RE: JMC Project 20029  
Edward Jones Office  
150 Bedford Road  
Town of North Castle, NY

**Response to Town Comments Submission**

**Town of North Castle Planning Department, July 4, 2020**

**Kellard Sessions Consulting, P.C. Memorandum, dated July 9, 2020**

# SITE LAYOUT & STRIPING PLAN

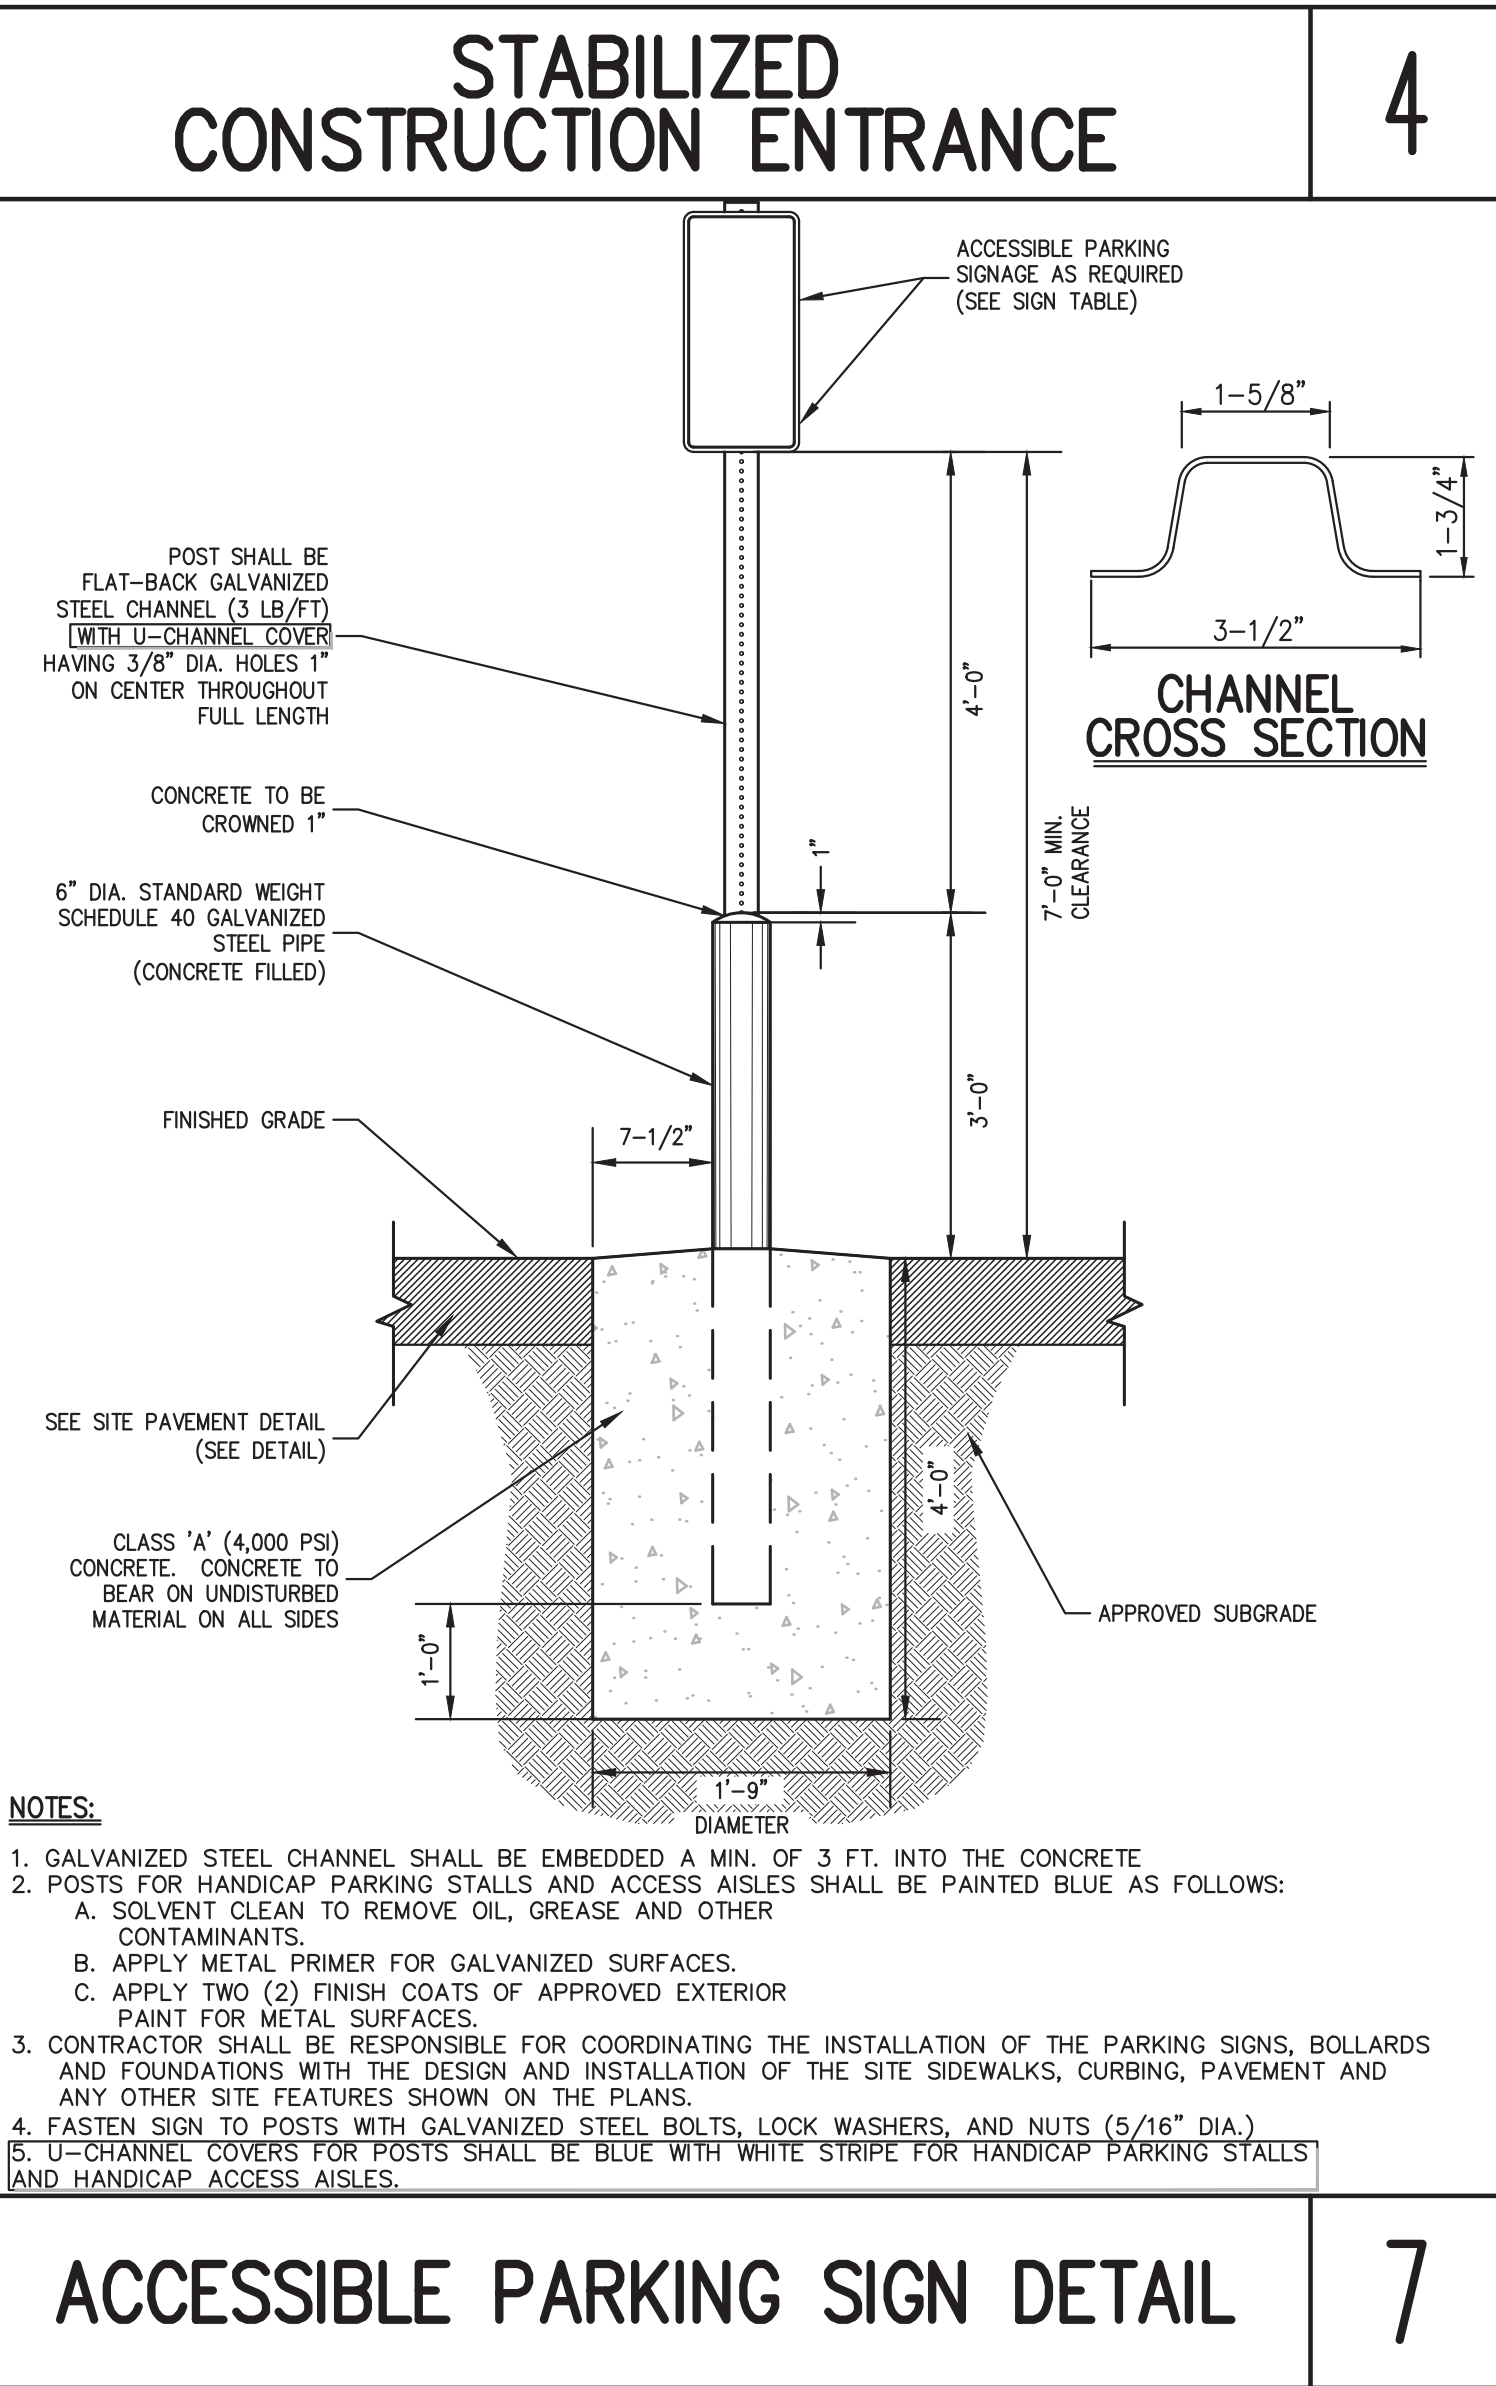
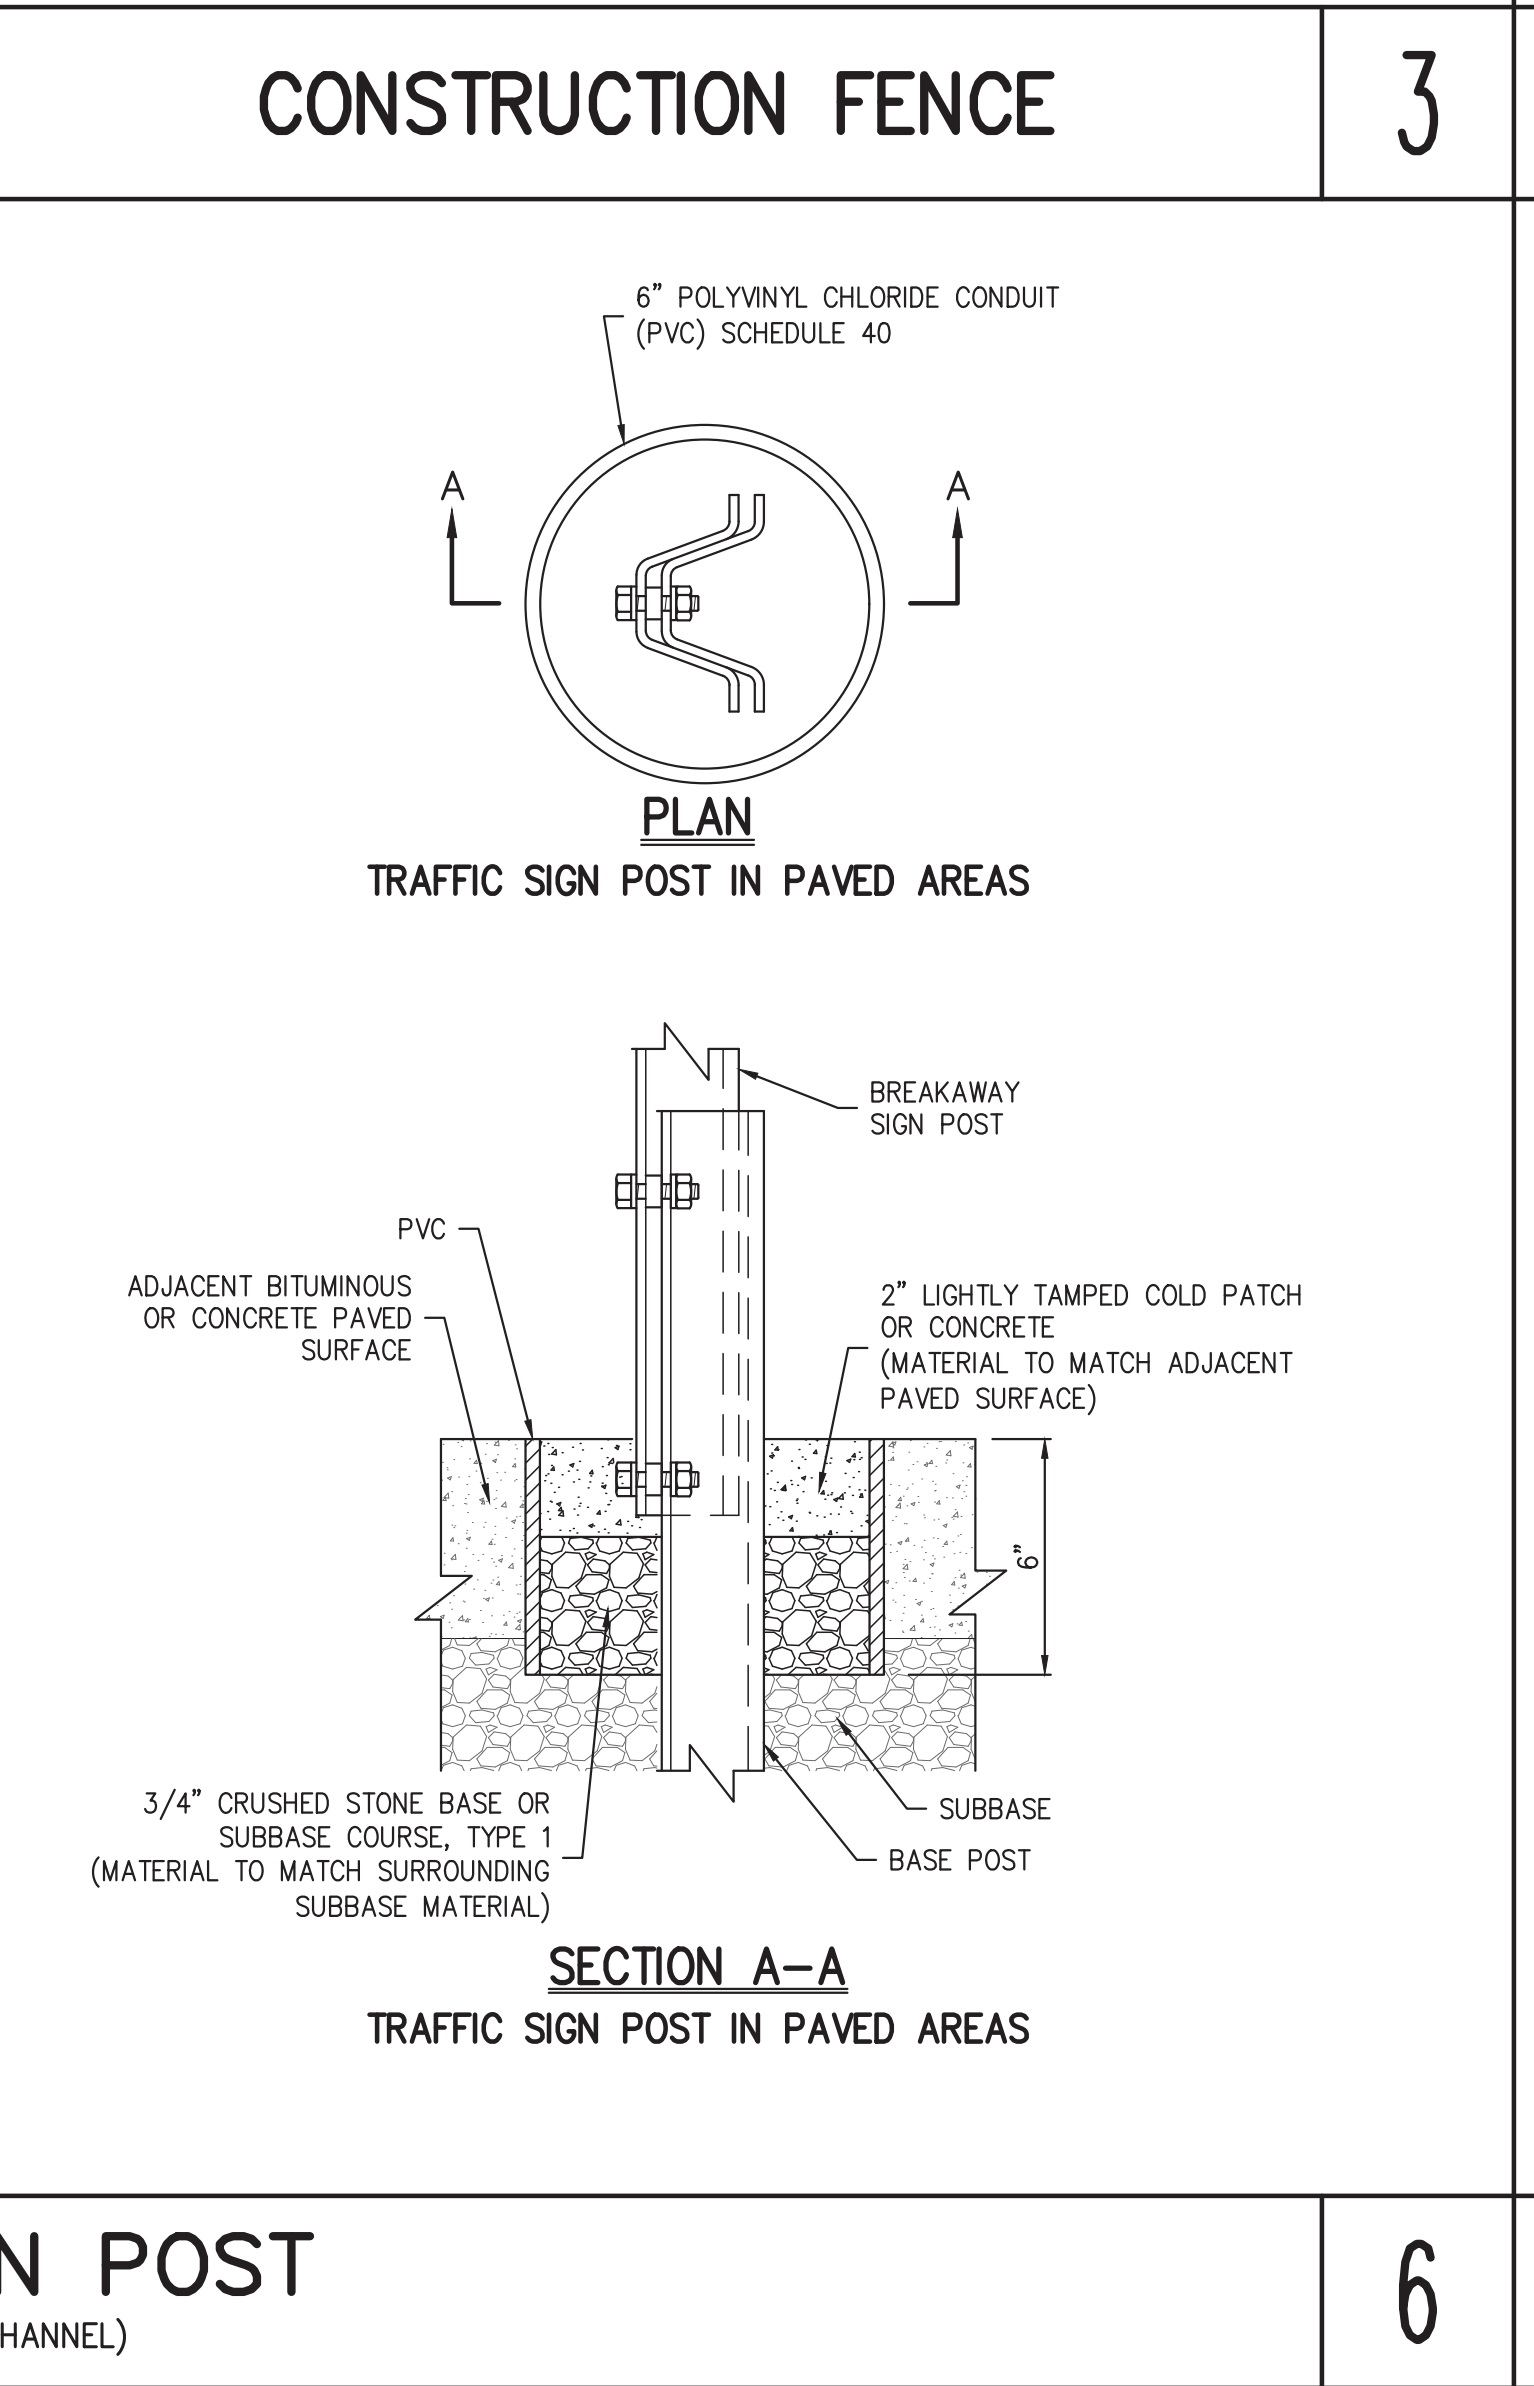
*The site plan shall be revised to depict the access drive dimensions in the vicinity of the new covered stairs on the eastern side of the building. Pursuant to Section 355-56.G. of the Town Code. The drive is required to be a minimum of 20 feet wide.*

*As previously noted, Section 355-56, G of the Town Code requires that access drives for parking areas serving between six (6) and twenty (20) spaces have a minimum width of 20 feet. The existing drive varies in width from approximately 12 to 15 feet. It appears an area variance will be required.*

*As previously requested, the plan has been revised to permit suitable access from the handicap access drive aisle to the ramp. However, the location of the “No Parking” sign shall be adjusted outside of the travel path.*

The access drive width has been dimensioned in the area of the proposed covered stairs. The width of the existing driveway has been determined to be existing non-conforming and will not be reduced in width under the proposed plan. Furthermore, based on the easterly curb location refinements and replacement the access drive has been increased to the maximum extent while also maintaining a planting bed along the easterly property line. The plan has been reviewed and approved by the Armonk Fire Department. Please refer to email correspondence from Armonk Fire Chief (Chief Phil Goulet), dated 07/07/2020.

The site plans have been revised to depict dimensions of the access drive, the width of which has not been reduced. Furthermore, based on the easterly curb location refinements and replacement the access drive has been increased to the maximum extent while also maintaining a planting bed along the easterly property line.

The site plans have been revised to relocate the proposed “No Parking” sign outside of the sidewalk travel path.
